UNITED STATES PATENT AND TRADEMARK OFFICE

| APPLICATION NO. | FILING DATE | FIRST NAMED INVENTOR | ATTORNEY DOCKET NO. | CONFIRMATION NO. |
|-----------------|-------------|----------------------|---------------------|------------------|
| 10/823,408 | 04/13/2004 | Susumu Moriya | 0388-043850 | 3243 |

Office Action Summary

FIG. 4A

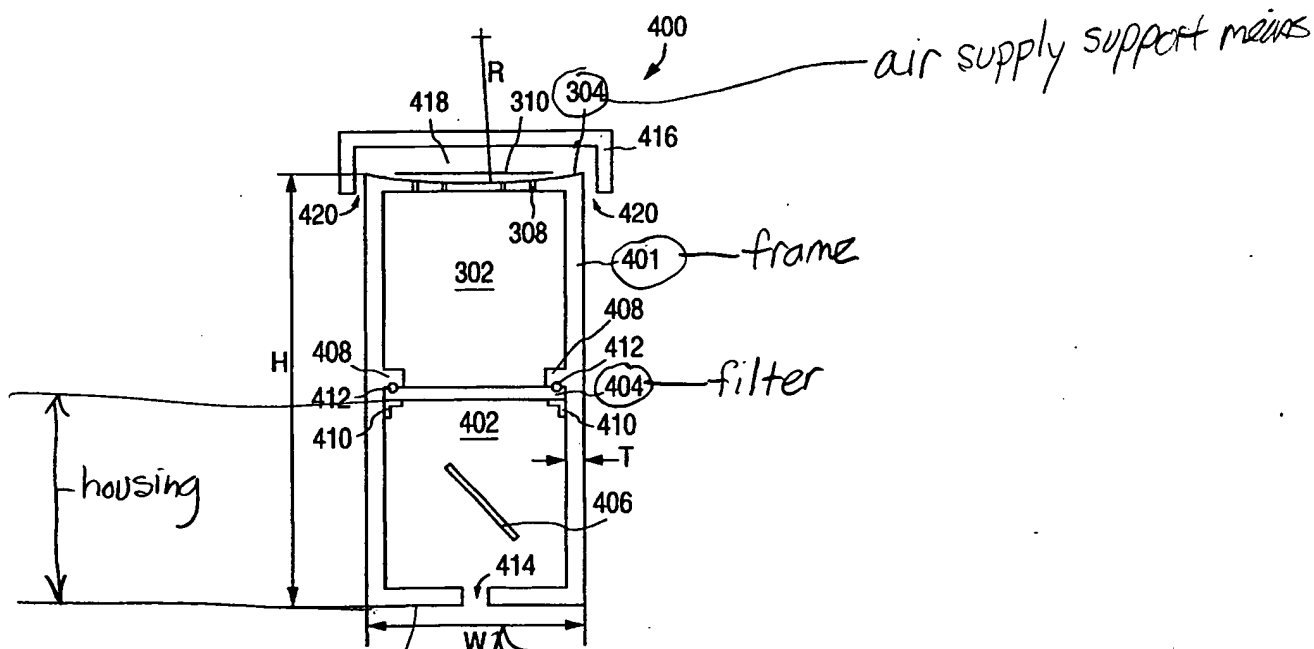
Adam et al. Teach the claimed invention as shown on the attached marked up drawing figure 4A. Adam et al. Fail to teach the specifics of the location of his fan/air supply. Adam et al does show an air supply at 414 in figure 4B. It would have been obvious to one of ordinary skill in the art at the time the invention was made to enclose the air supply within the same housing as the filter for the purpose of making the unit more portable and requiring less space. Although Adam et al. does not show any particulars of his air supply, it may even be in the same housing as claimed.

fan could be attached here making a single air supply unit

inherent fan provides
air @ inlet 414
could be attached
@ bottom of frame

図 5

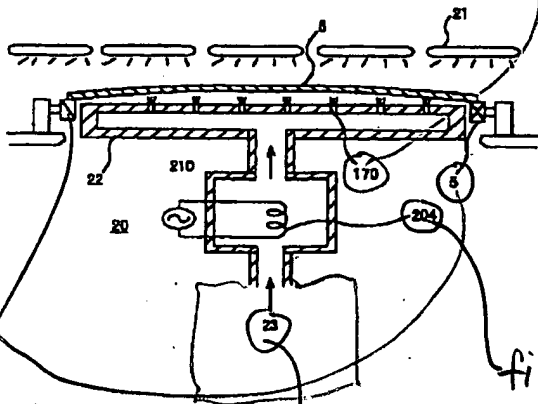
Nagate et al. Teach the claimed invention as shown on the attached marked up drawing sheets 7 and 8. Nagate et al. Fail to teach the specifics of the location of his fan/air supply. Nagate et al does show an air supply at 23 in figure 5. It would have been obvious to one of ordinary skill in the art at the time the invention was made to enclose the air supply within the same housing as the filter for the purpose of making the unit more portable and requiring less

drive rotor

air supply support means

図 6

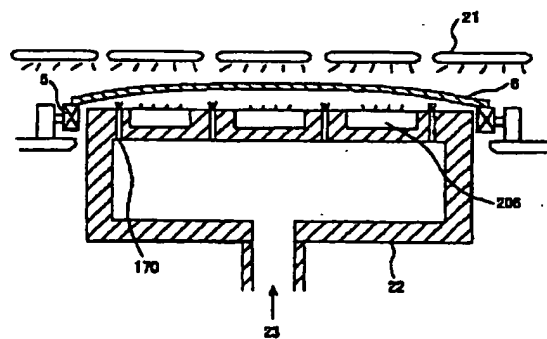
air supply means may be in same unit

【図10】

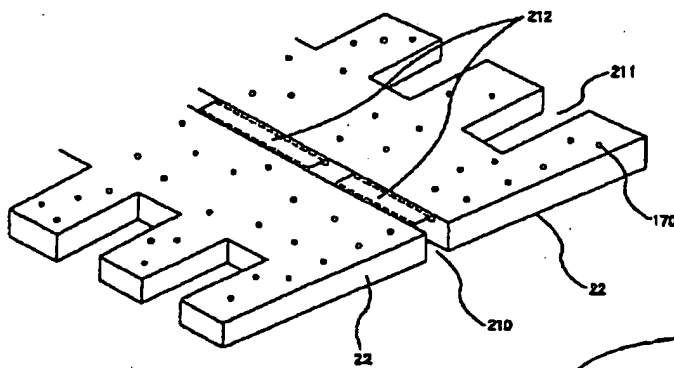
plurality of
units side by side
